SUBJECT: **TND-C-1-06 Final Development Plan Major Change & Preliminary Plat of 259 Lots for the Remaining Portion of Village at Magnolia Square Traditional Neighborhood Development**

SUBJECT: **TND-C-1-06 Final Development Plan, Development Review Committee (DRC)
Comments – Applicant Response**

SUBJECT: TND-C-1-06 Final Development Plan, TND VMS Additional Comments – Applicant Response

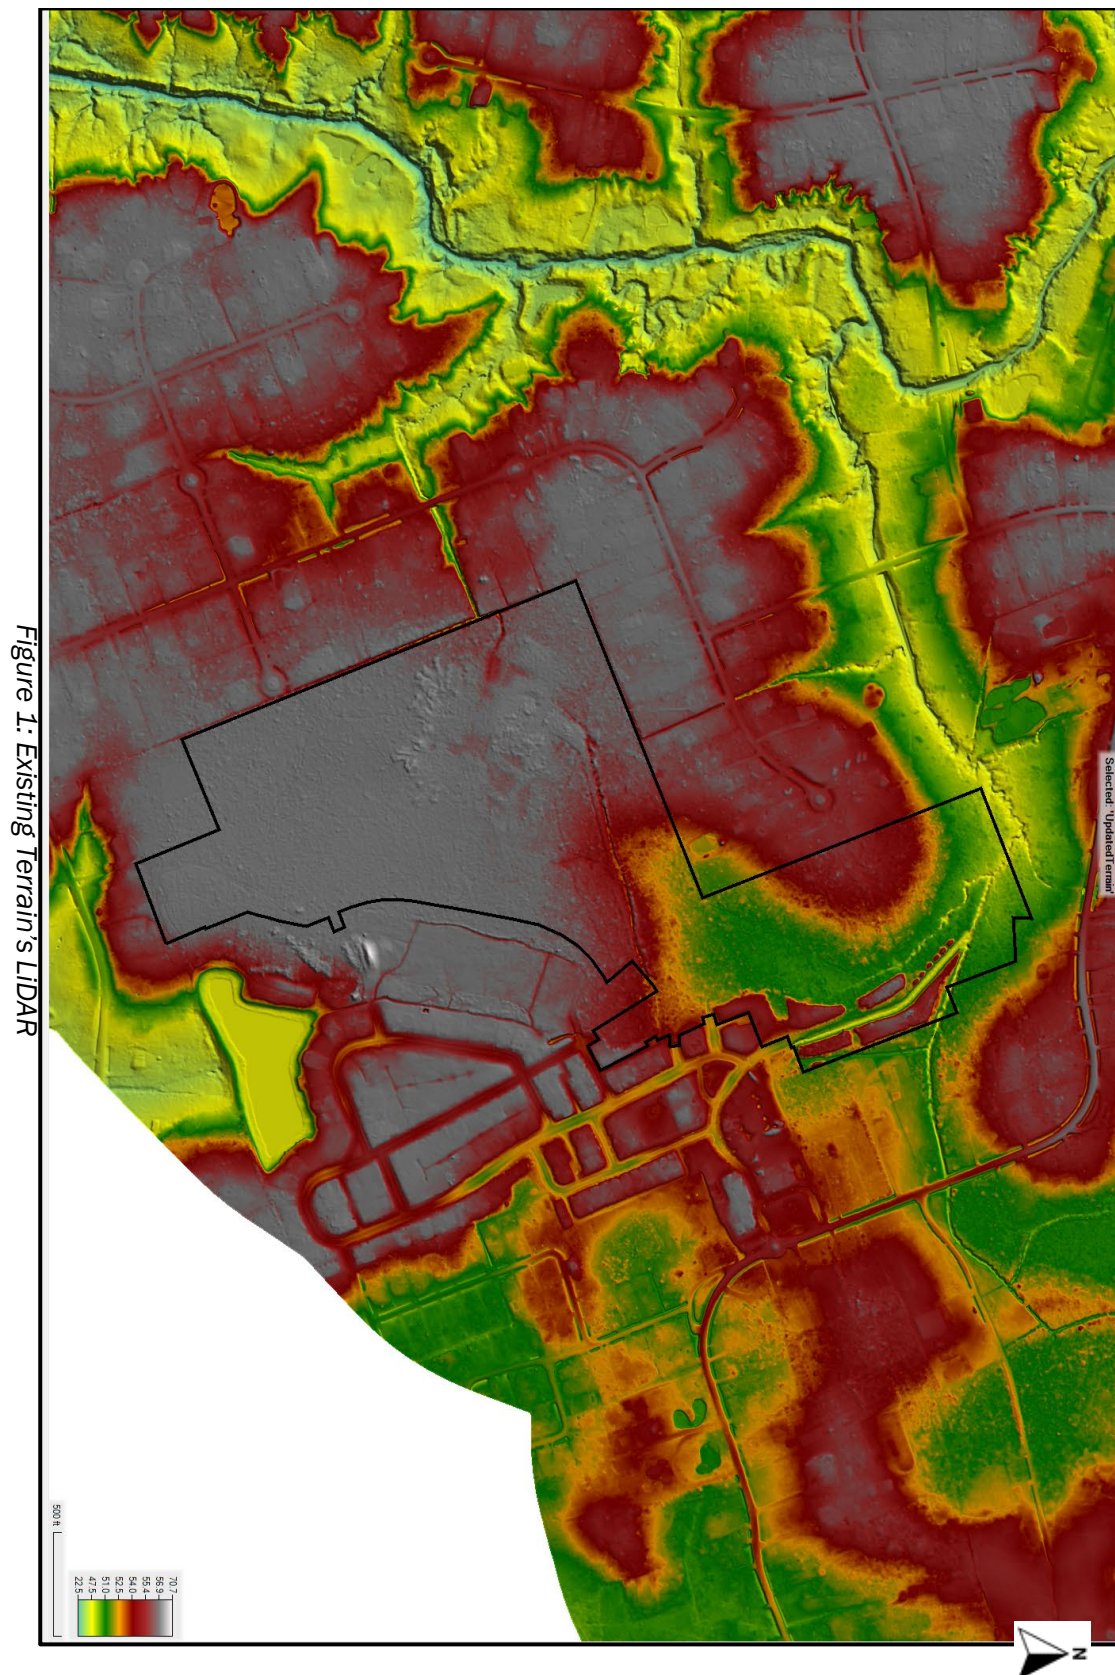
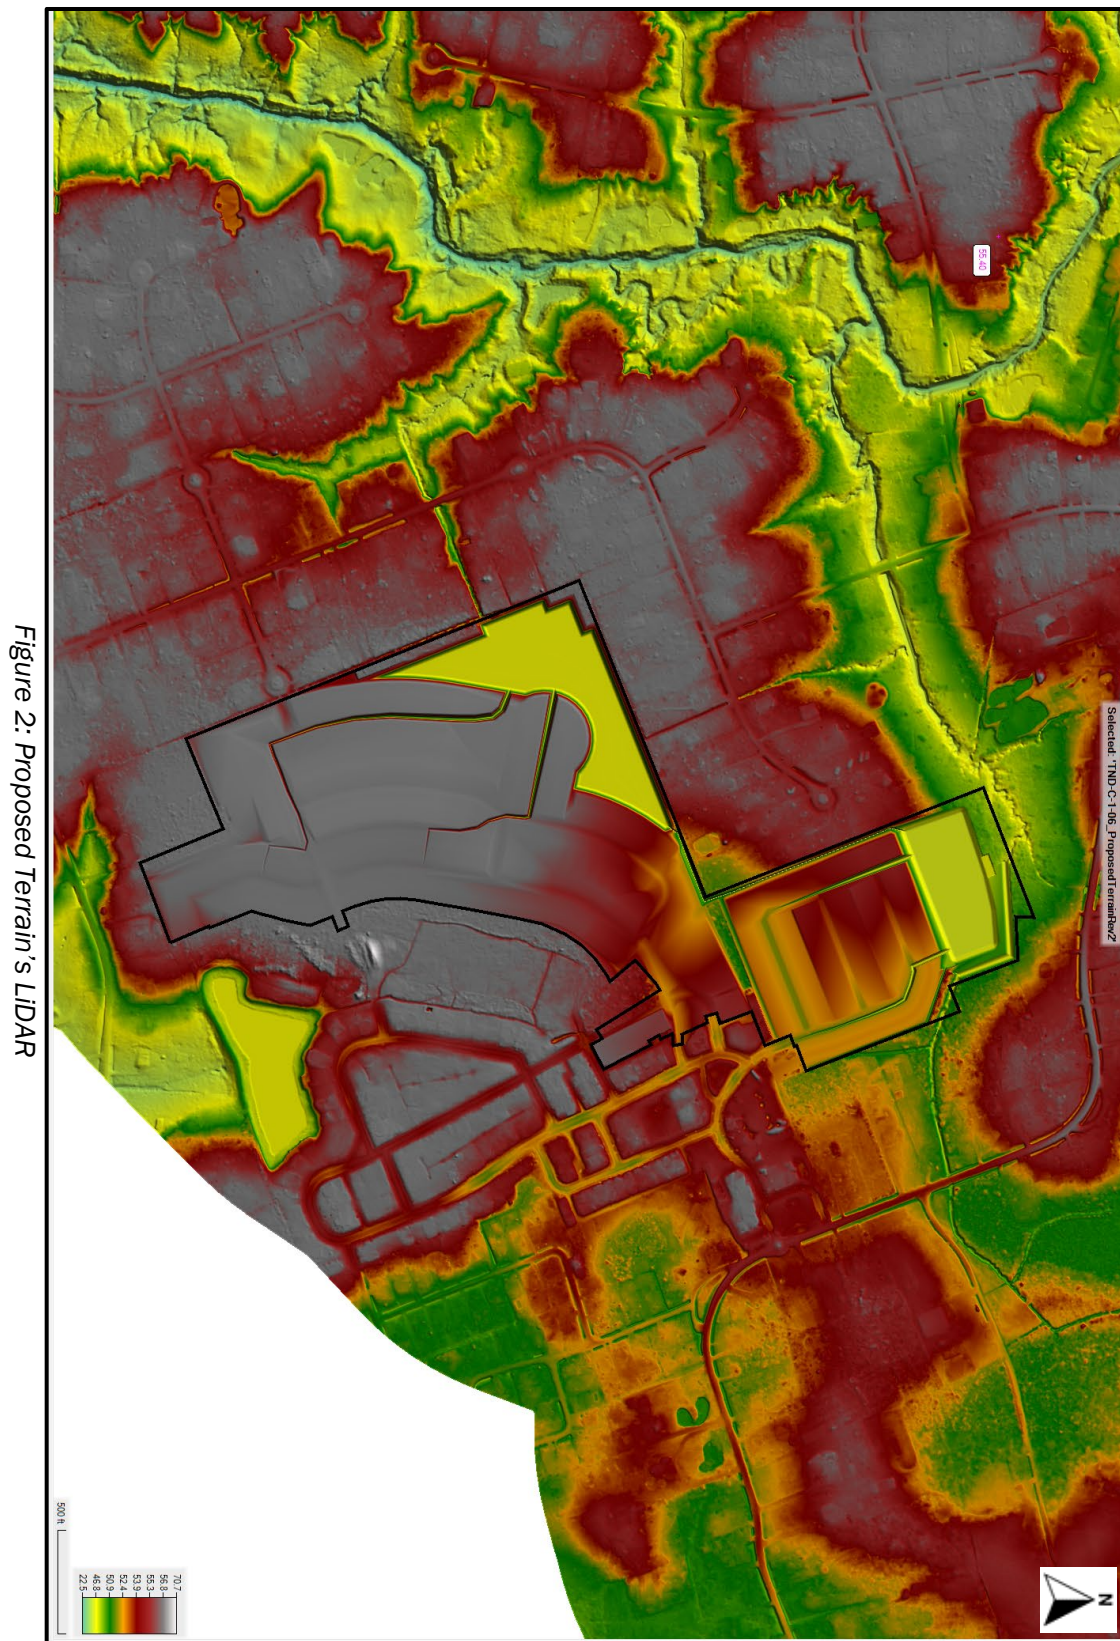
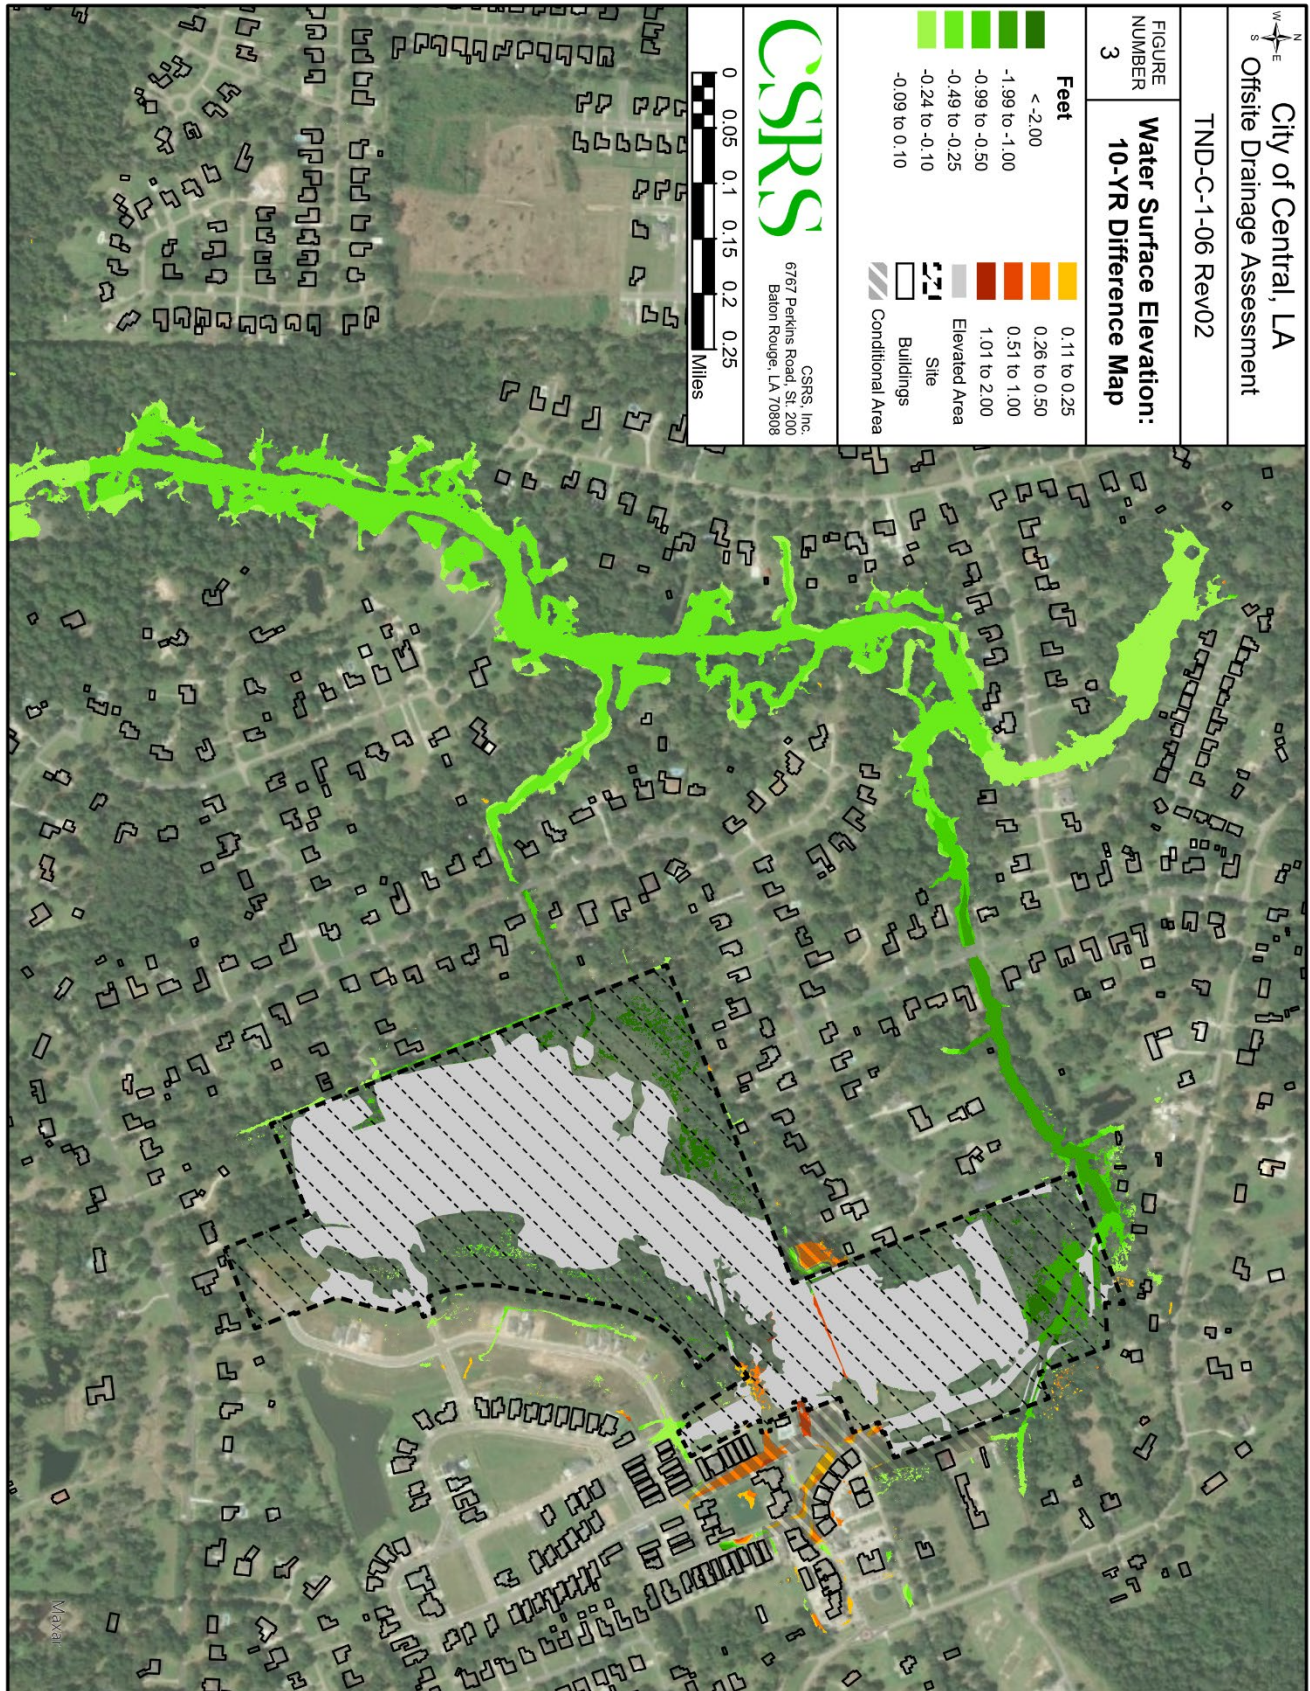
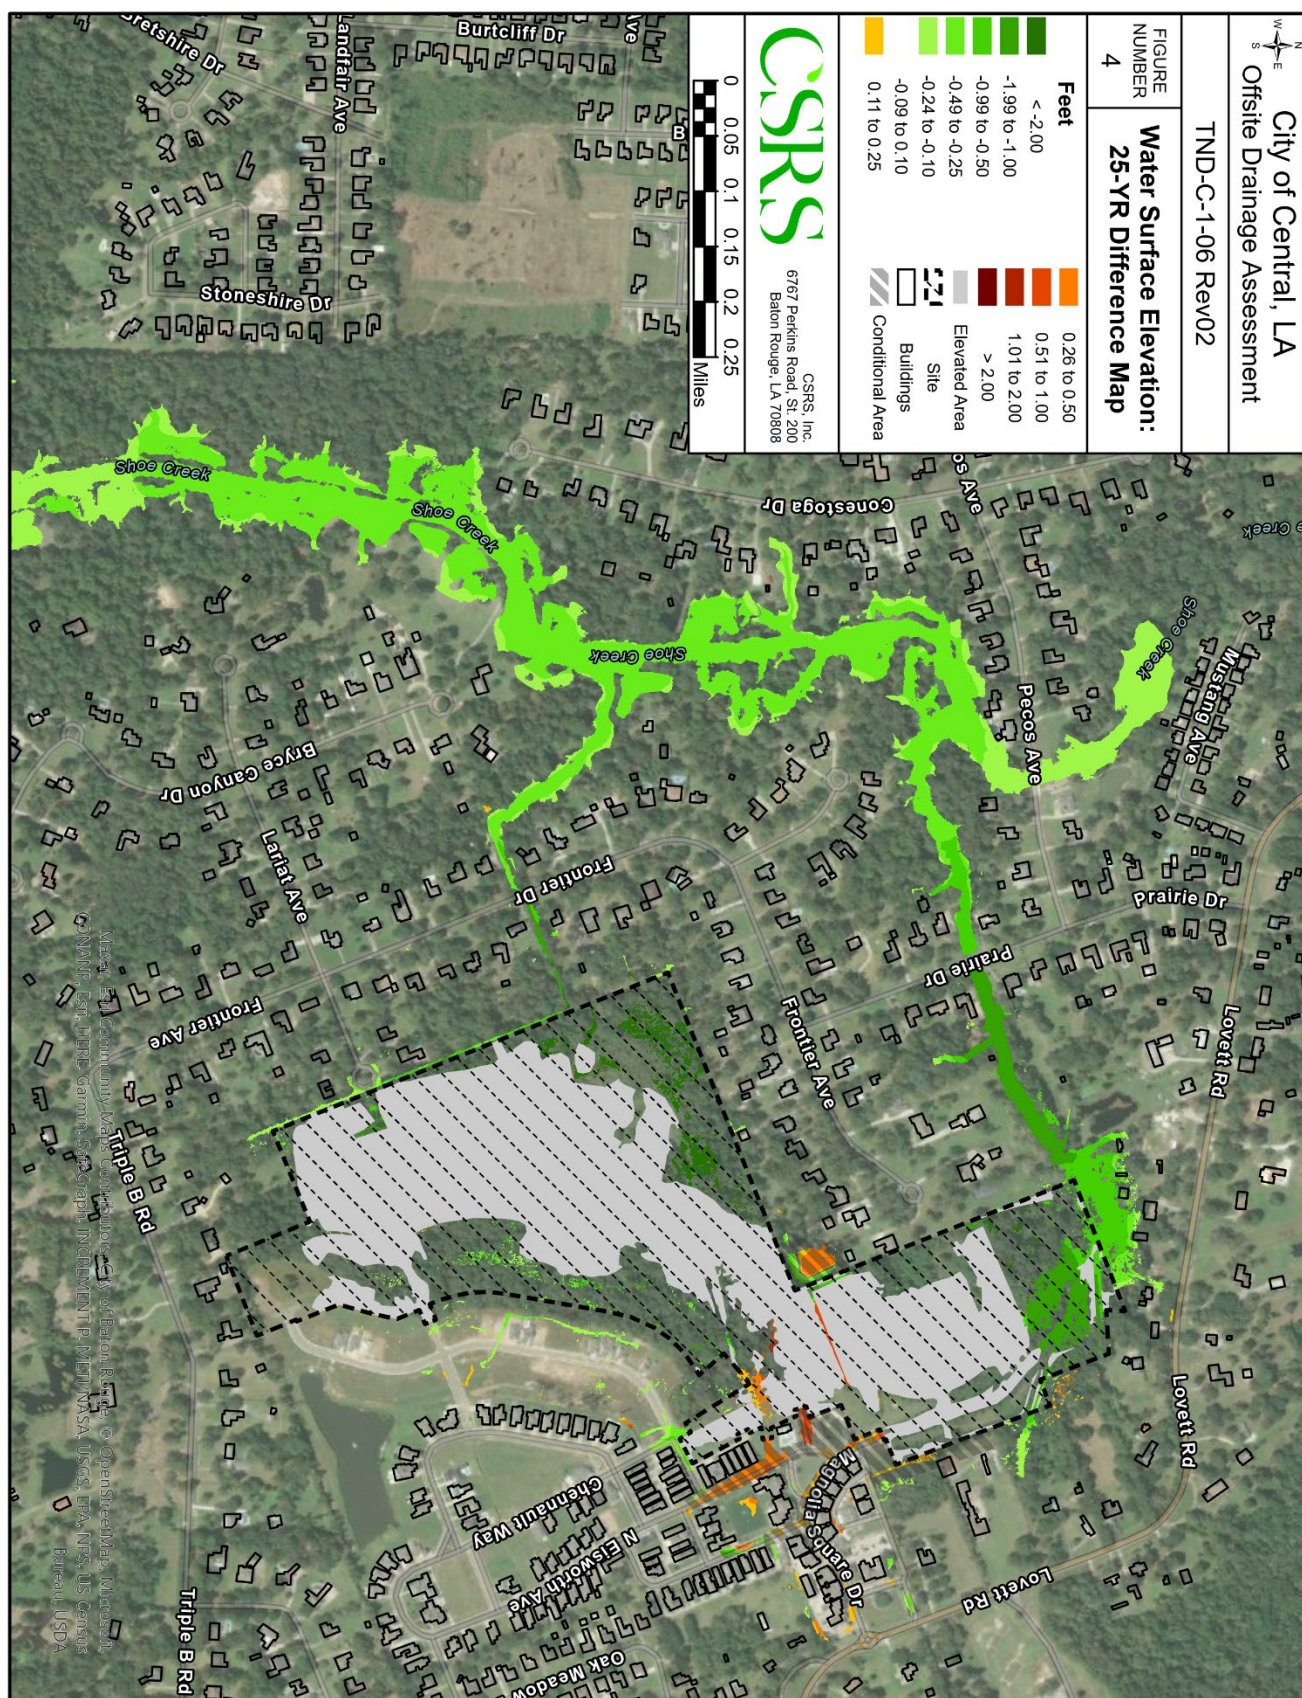
The peak water surface elevations from each storm event were extracted from the Updated EHM and Post-Development Hydraulic Models and compared to one another as shown in *Figures 3, 4, and 5*.

The comparisons reveal the following impact to peak water surface elevations beyond the development site for all storm events:

-
- Decreases between 0.1 and 2.0 feet along Shoe Creek downstream of the site and directly downstream of the pond outfalls.

The comparison also revealed the following impacts to peak water surface elevations beyond the development site for all storm events, however, after review with the applicant, the current proposed development does not have the detailed layout necessary for the ODA to accurately reflect capturing the surface runoff which results in revealing these impacts. It is suggested that these impacts be reevaluated after the applicant is allowed to further design the development.

- Increases between 0.1 and 0.5 feet in the back of adjacent lots on the Southside of Frontier Ave; and
- Increases between 0.1 and 0.5 feet in the back of adjacent lots on the Westside of Lovett Rd near the proposed extension of Magnolia Square Rd.
